RENESAS TECHNICAL UPDATE

Product Category	MPU/MCU	Document No.	TN-SH7-A883A/E	Rev.	1.00
Title	Correction of errors regarding the SRAM Interface on Internal Bus of the Bus State Controller (BSC)		Information Category	Technical Notification	
Applicable Product	<ul style="list-style-type: none"> • SH7214 Group • SH7216 Group 	Lot No.	Reference Document	<ul style="list-style-type: none"> • SH7214 Group, SH7216 Group User's Manual: Hardware Rev.4.00 (R01UH0230EJ0400) 	
		All lots

Figure 9.41 Example of Connection with 16-Bit Data-Width SRAM with Byte Selection

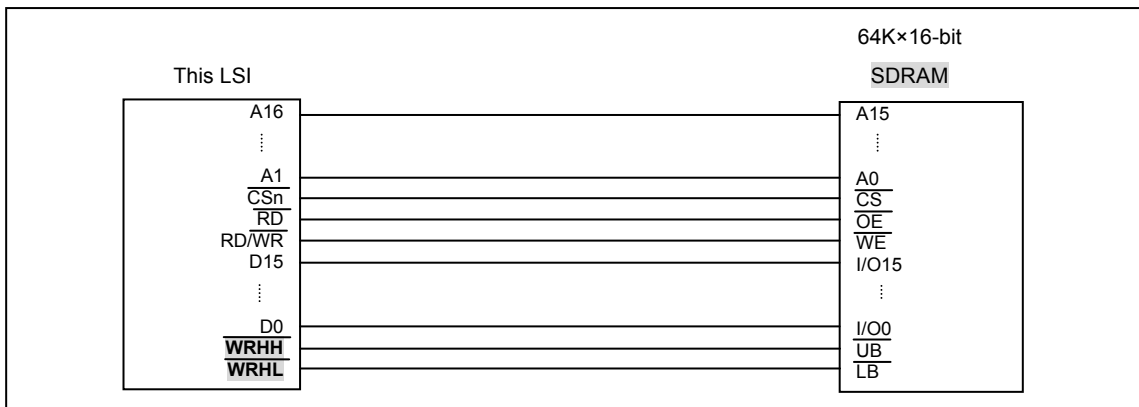
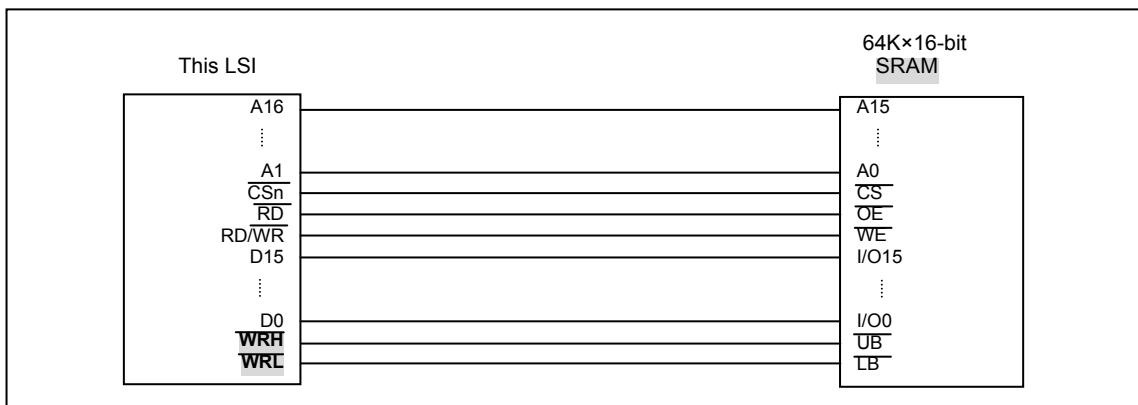
9.5.8 SRAM Interface with Byte Selection

Erroneous:

Corrected:
